Request for Board of Commissioners Action  
September 18, 2012

To: Honorable Board of Commissioners  
From: Tommy Combs, Interim Manager  
Subject: **Ward Farm Village Preliminary Plat**

**APPENDIX A**  
**WARD FARM VILLAGE SITE PLAN**  
**(1 SHEET)**

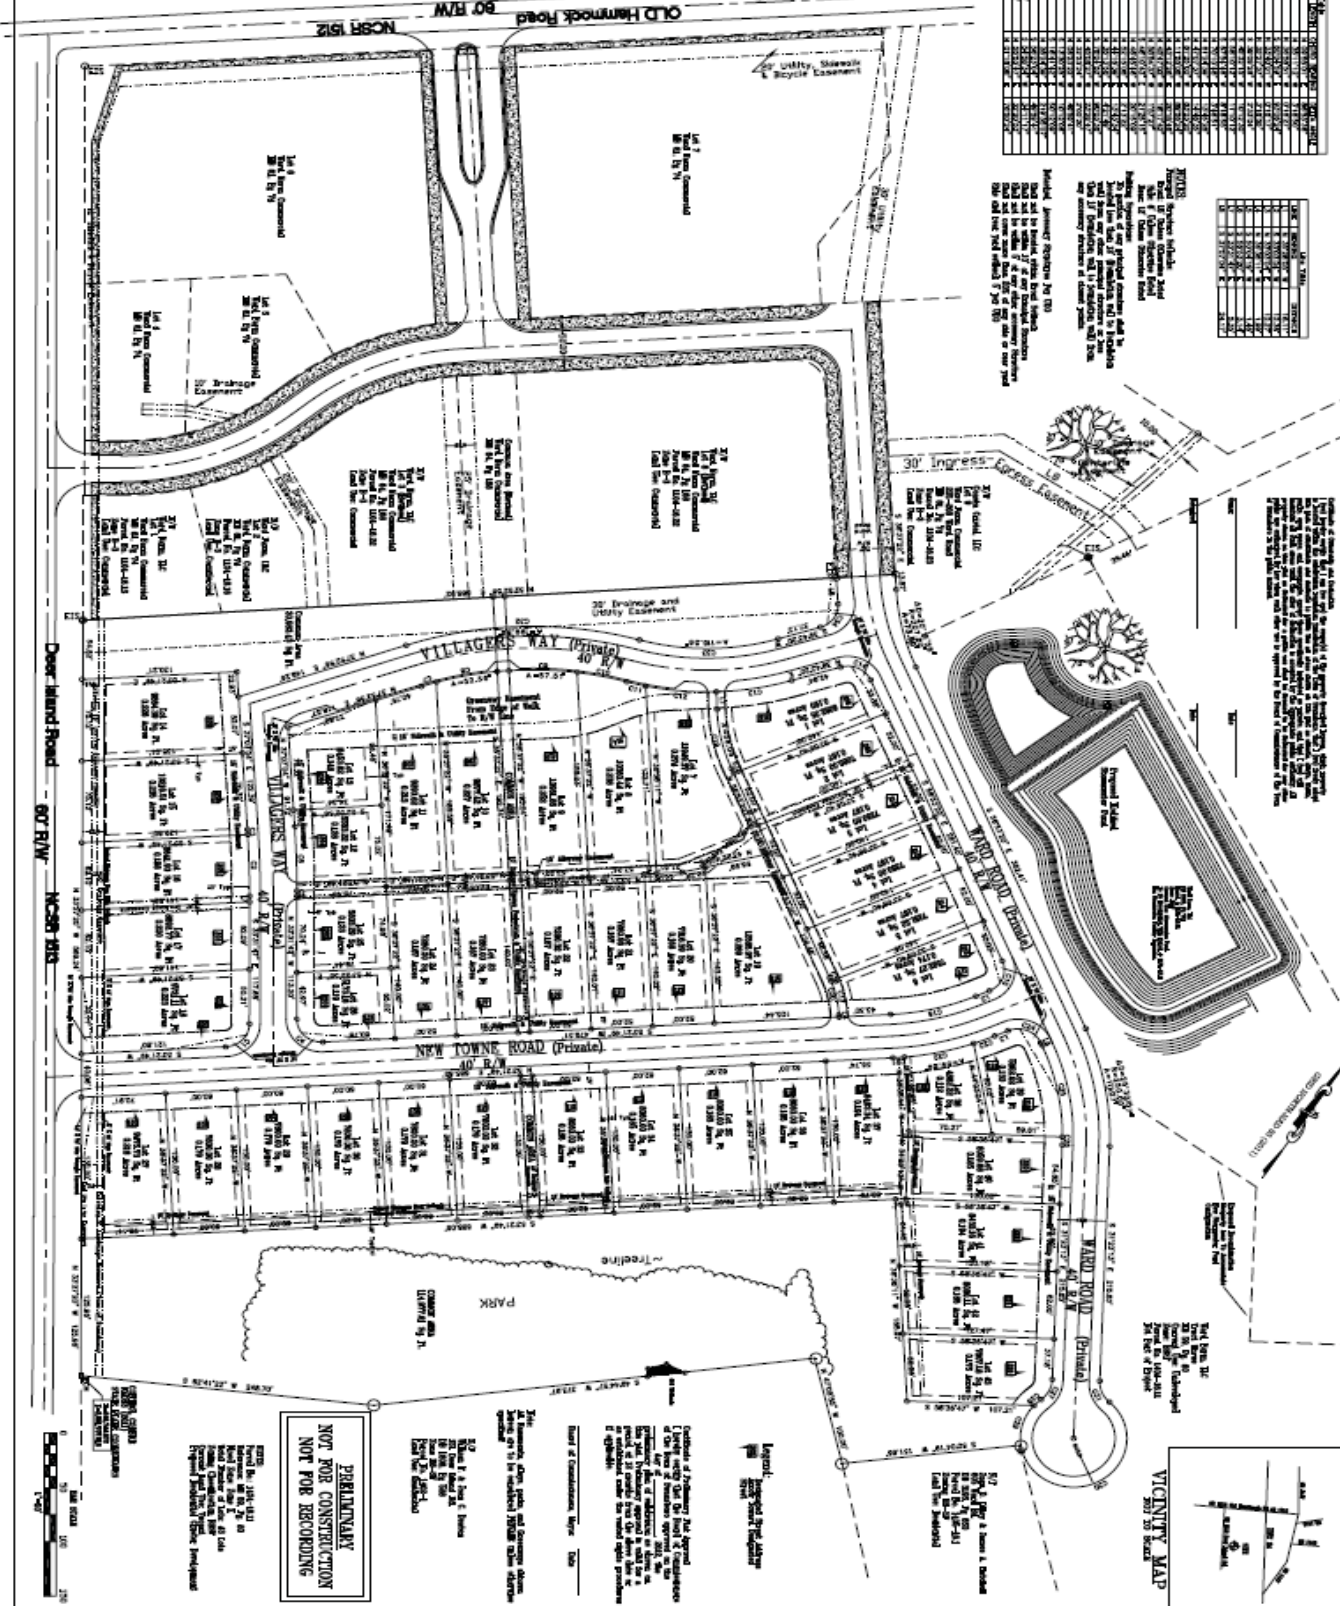
- 6) Section 20-17: Lots. The requirements of Section 20-17 appear to have been met.
- 7) Section 20-18: Streets. The requirements of Section 20-18 appear to have been met. A street lighting plan will be provided by Progress Energy for the first 10 lots.

- 9) Section 20-20: Utilities and Stormwater Management. The requirements of Section 20-20 appear to have been met. As-built drawings are required within 30 days of the completion or installation of all utility, stormwater, street, park, and recreational improvements.

- 10) Section 20-21: Sidewalks. The requirements of this section appear to have been met except for the requirement that the edge of the sidewalk must be one foot from the property line. This requirement is not met on Lots 7-13 due to a greenway easement proposed adjacent to the right-of-way. Staff feels that the intent of the ordinance has been met, and considers this to be a design consideration that the Board can review as a part of the plat review and approval.
